**Petition No. 1406A
Charter Oak Borrower, LLC
600 Iranistan Avenue, Bridgeport, Connecticut**

**Development & Management (D&M) Plan
Staff Report
May 22, 2025**

Site Plan 3.0 specifies one additional foot of fill throughout the entire site. Final fill elevations will be determined by a licensed surveyor in the State of Connecticut.

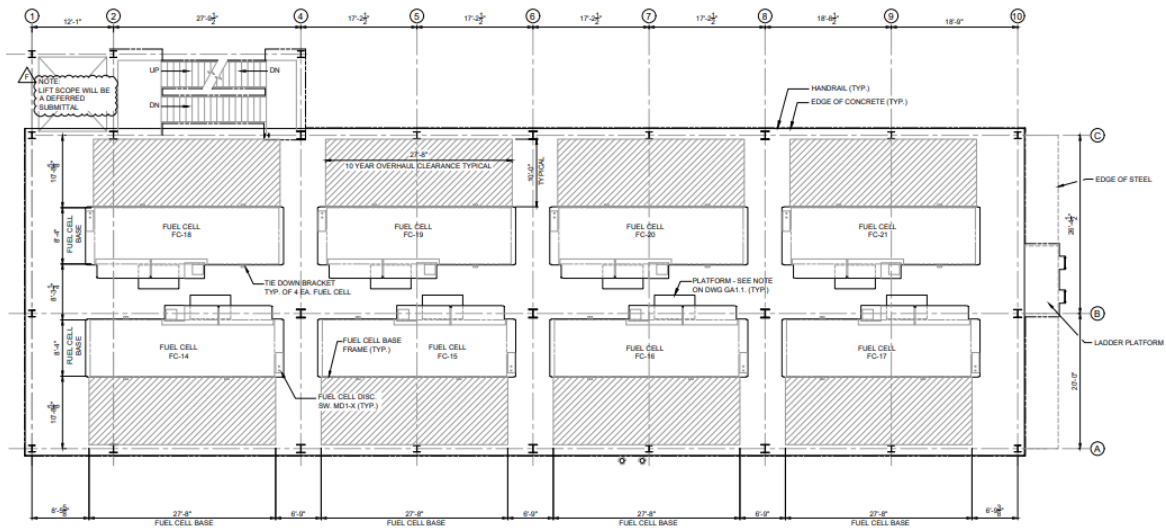
f. Plans for an additional one-foot of fill as a flood protection measure for the facility;
